Estates at Cathedral Pines
Trip Generation & Access Technical Memo
(LSC #S224150)
EPC PCD File No. PUDSP2210 & SF2234
January 8, 2024

RE: Estates at Cathedral Pines
El Paso County, CO
Trip Generation & Access Technical Memo
LSC #S224150

STOPPING SIGHT DISTANCE
 ESTATES AT CATHEDRAL PINES
 JOB NO. 25260.00
 8/22/2023
 SHEET 1 OF 3

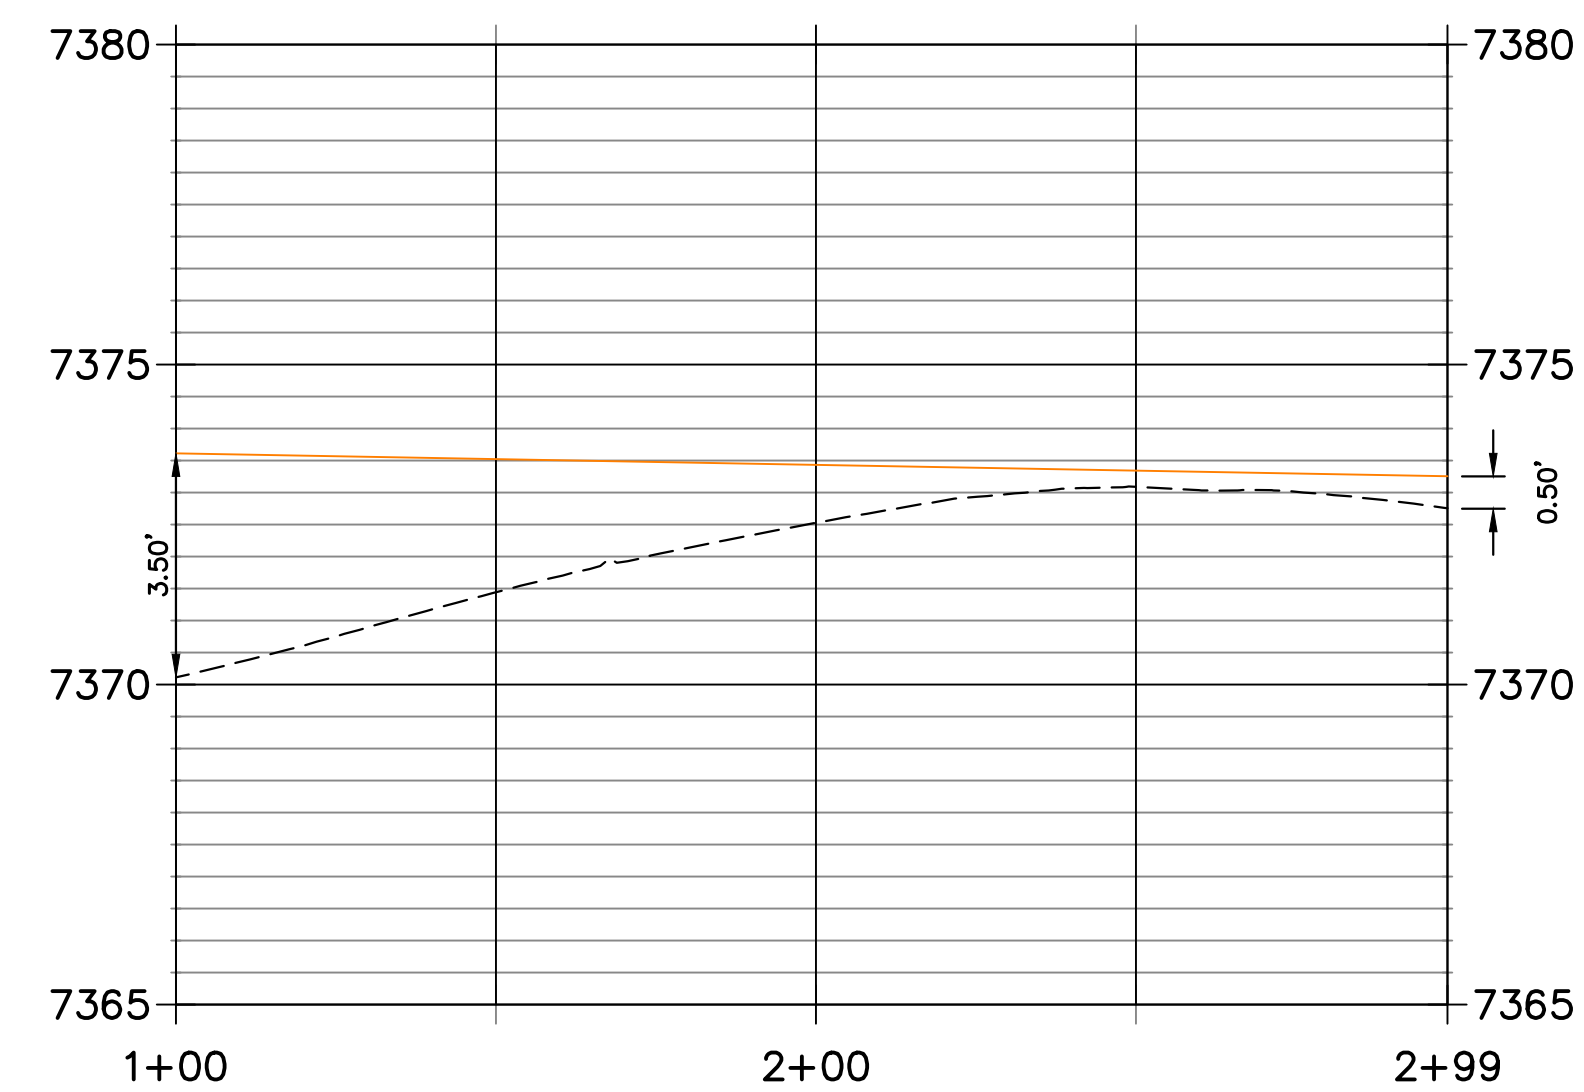
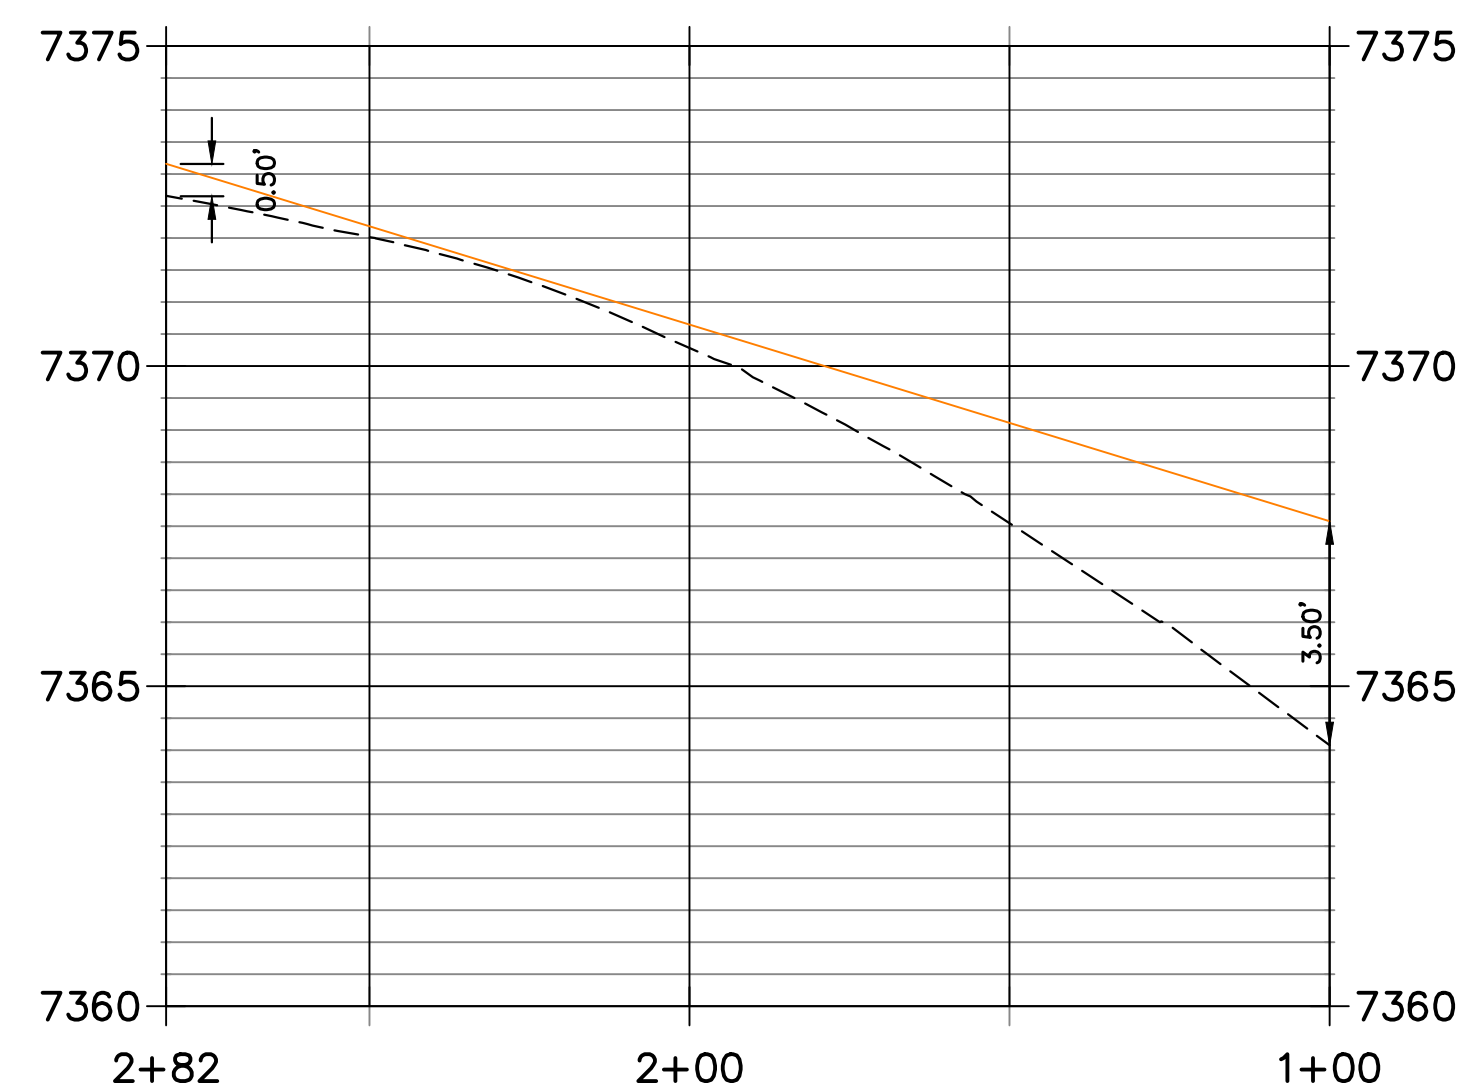
Provide exhibit of intersection sight distance and state what the sight distance specifically is. The stopping sight distance exhibits do not depict the intersection sight distance.

STOPPING SIGHT DISTANCE
 ESTATES AT CATHEDRAL PINES
 JOB NO. 25260.00
 8/18/2023
 SHEET 1 OF 1

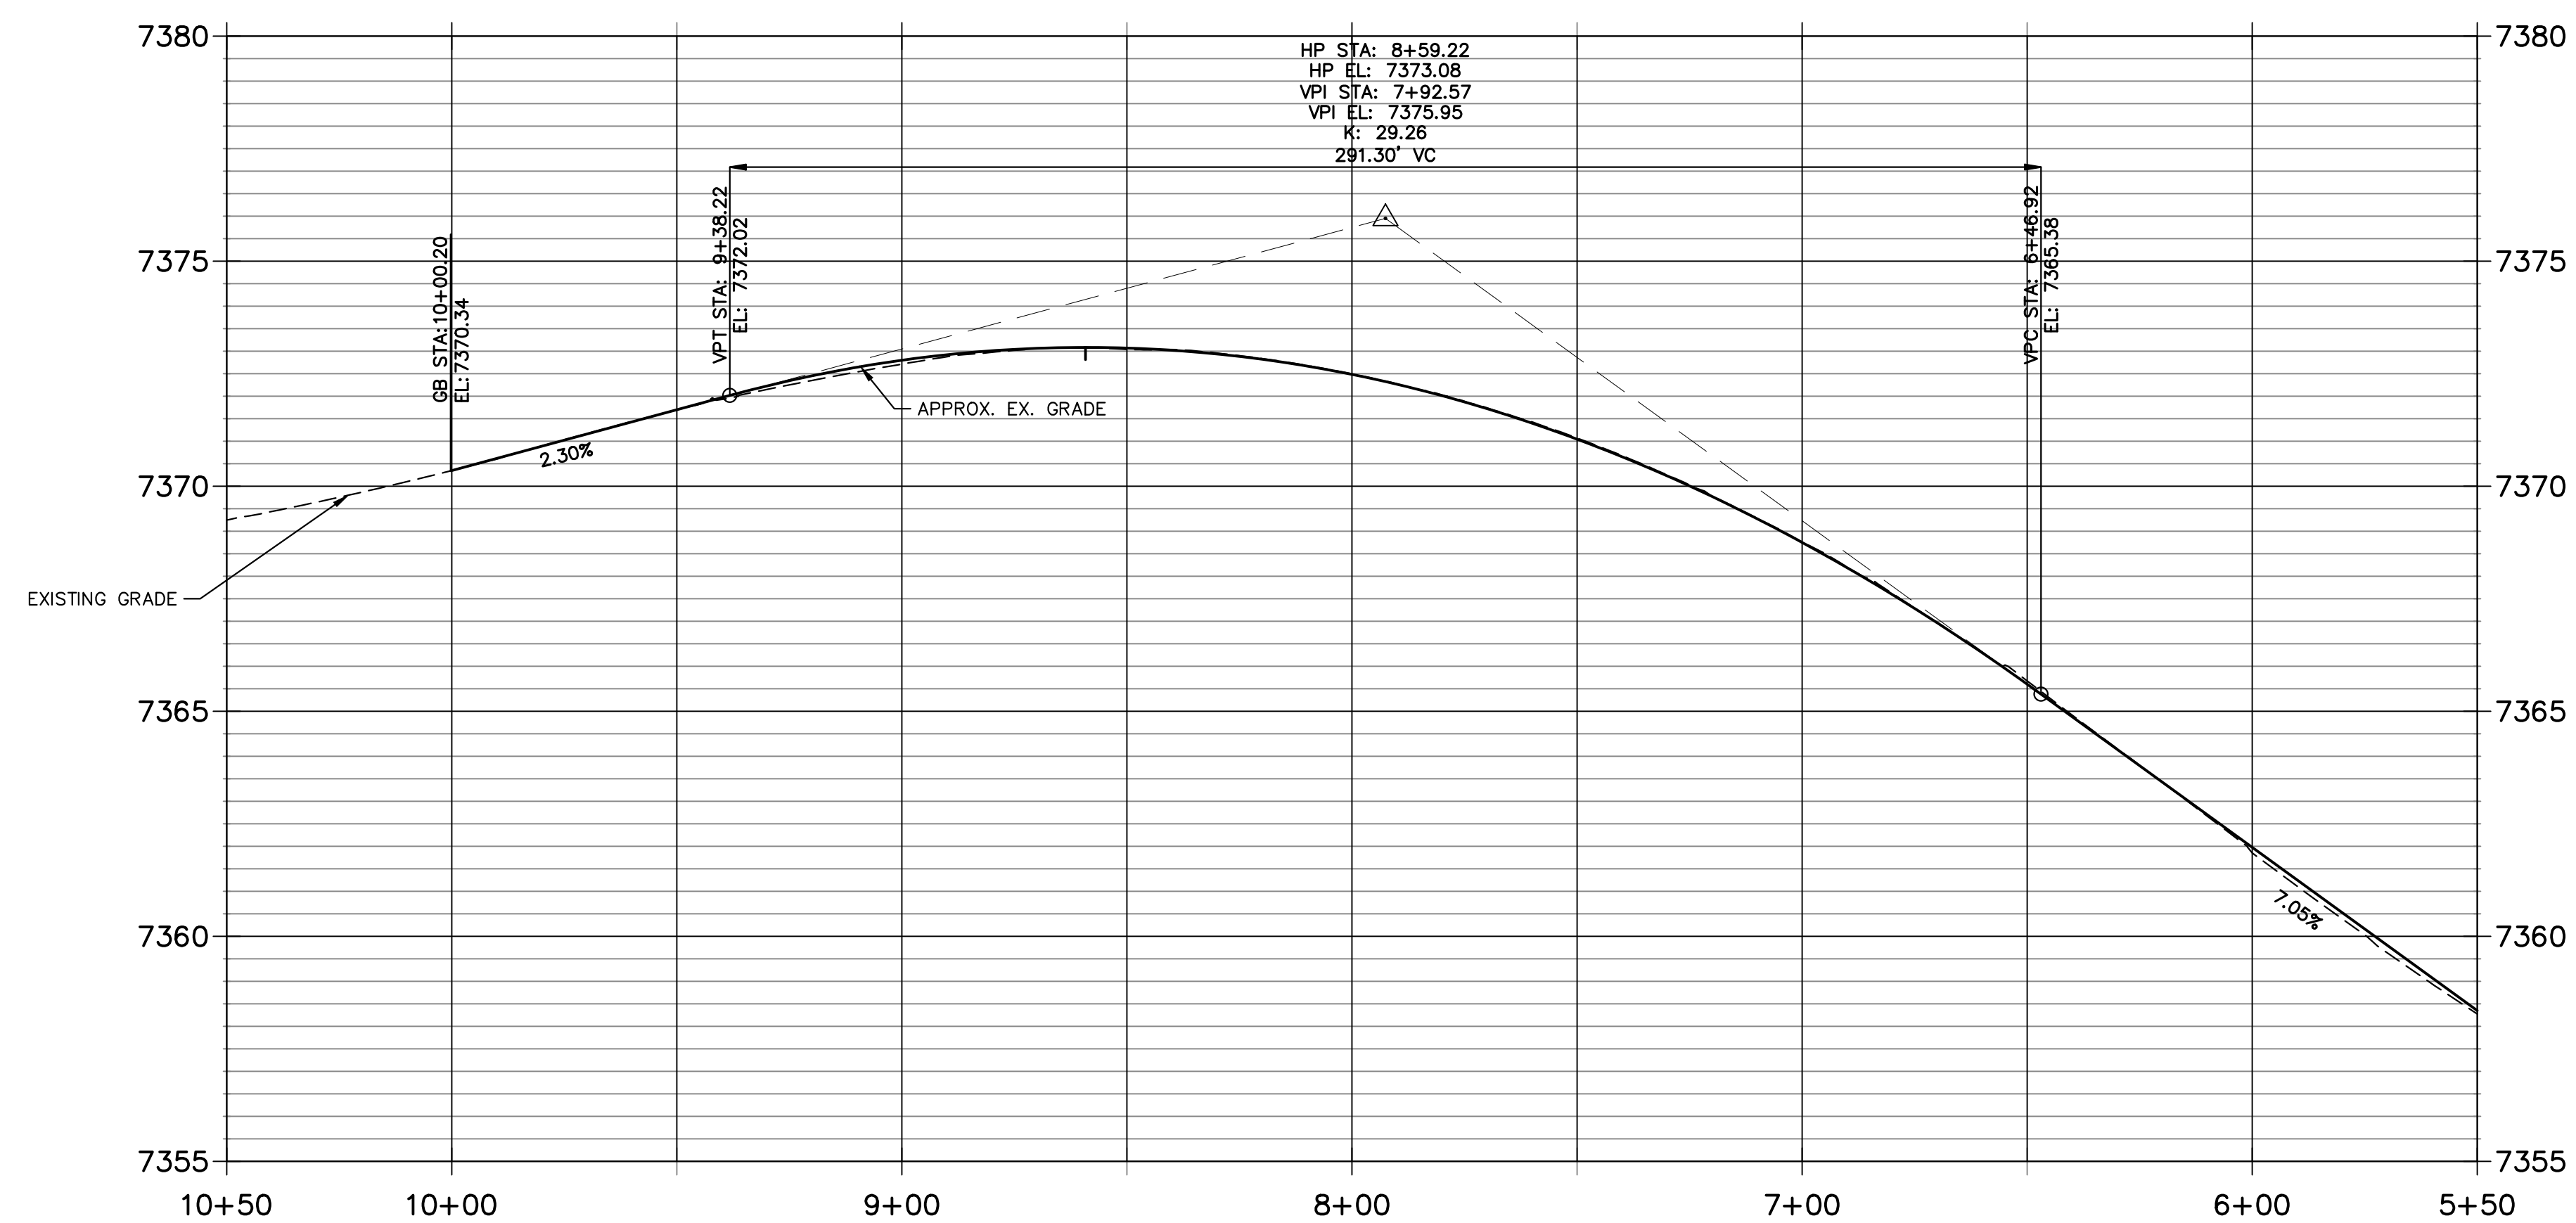
Provide exhibit that shows intersection sight distance Per Table 2-21 and Figure 2-33
